February 5, 2024

**Re: Powerton Generation Station
Log No. 2021-100029
Bureau ID# W179801008
MWG Response to Permit to Operate a Coal Combustion Residual Impoundment Review
Letter**

SCALE AT ANSI A	DRAWN	DZF	10/27/2022
1:24,000	CHECKED	BAS	10/27/2022
BAS PROJECT No.	21141401		FIGURE: 5

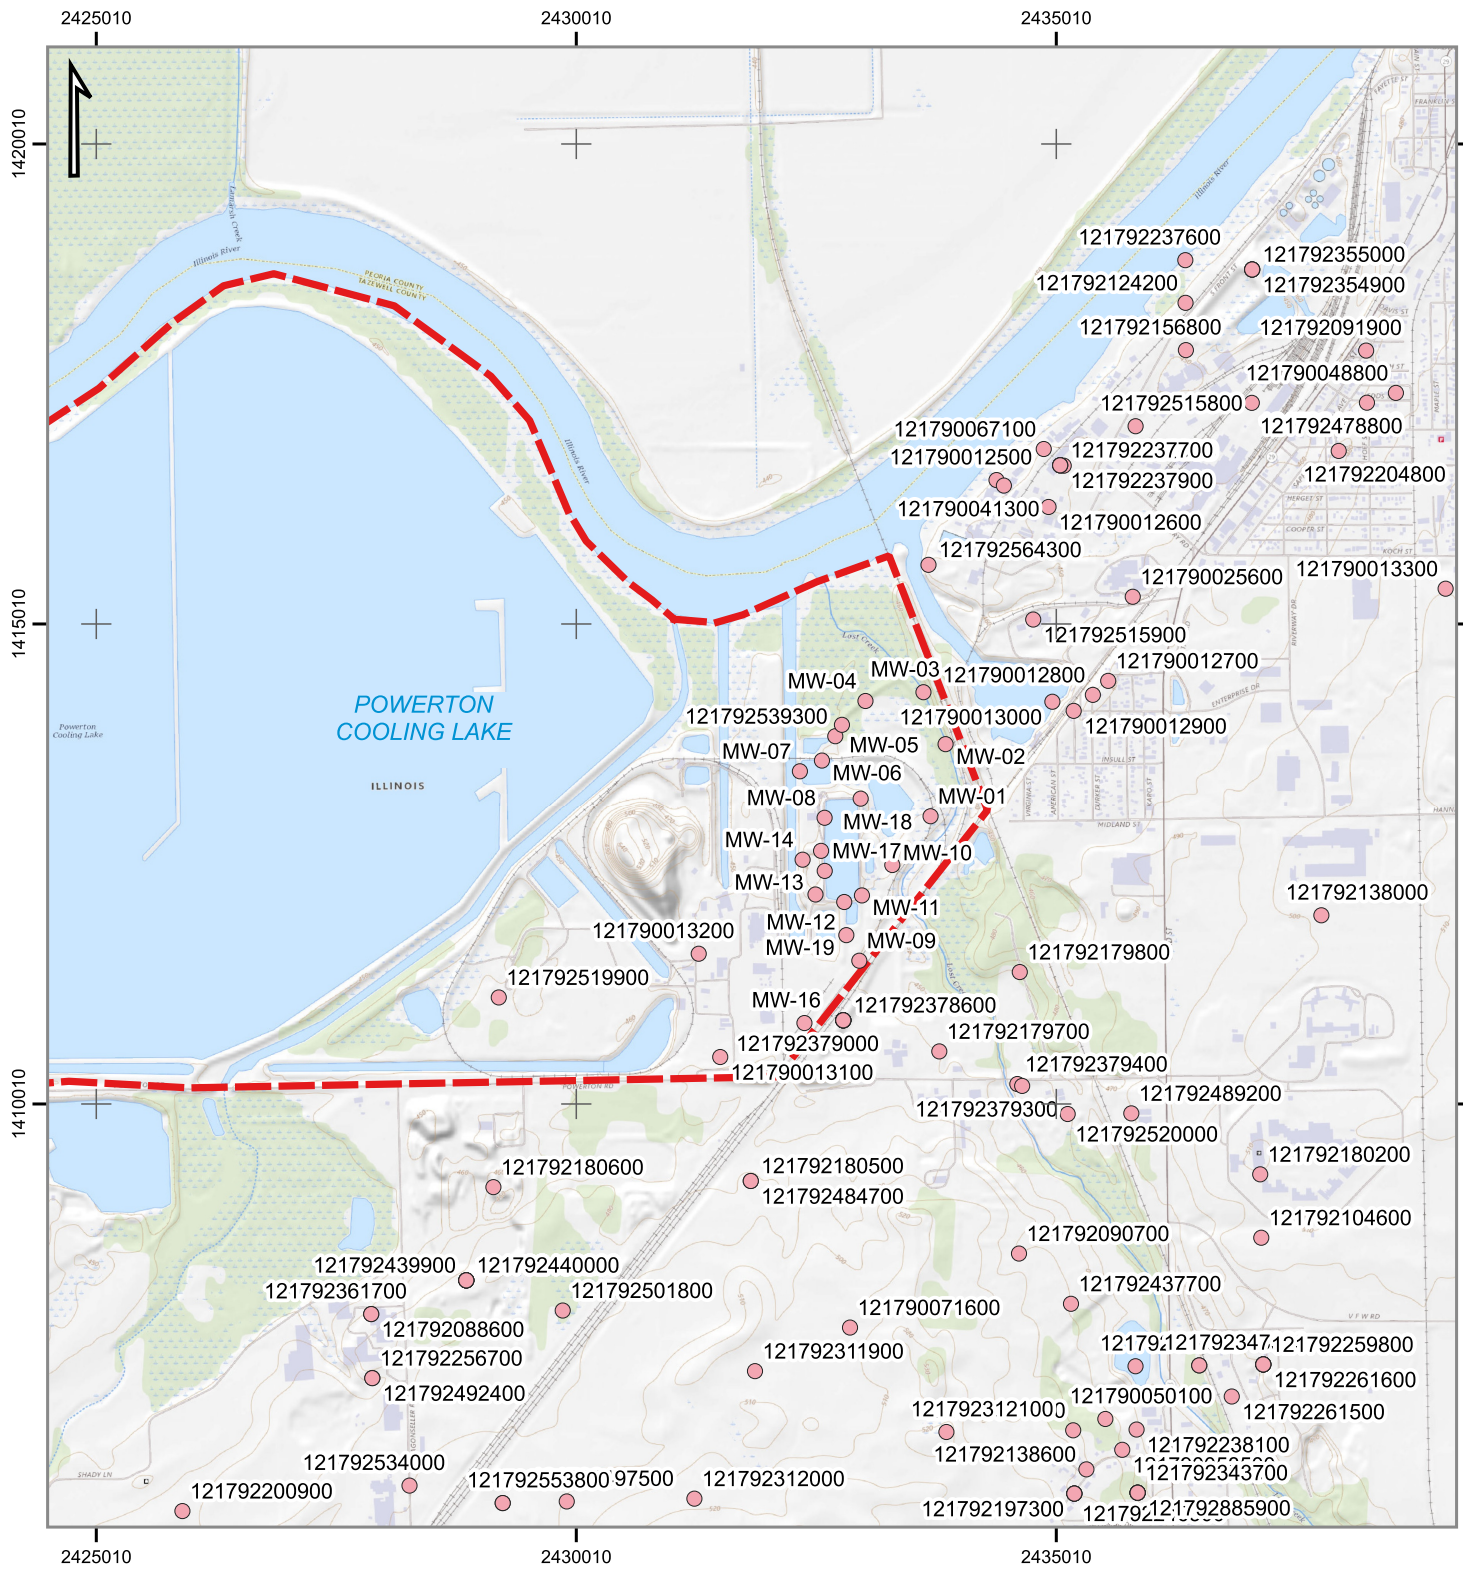
54) The requested location figure is Figure 5 from the groundwater modeling report that was included in support of the FAB closure application, submitted on October 28, 2022. Both the previously provided Figure 5 and Table 9-1 from the Application with the borehole stratigraphy used are provided in Attachment 8.
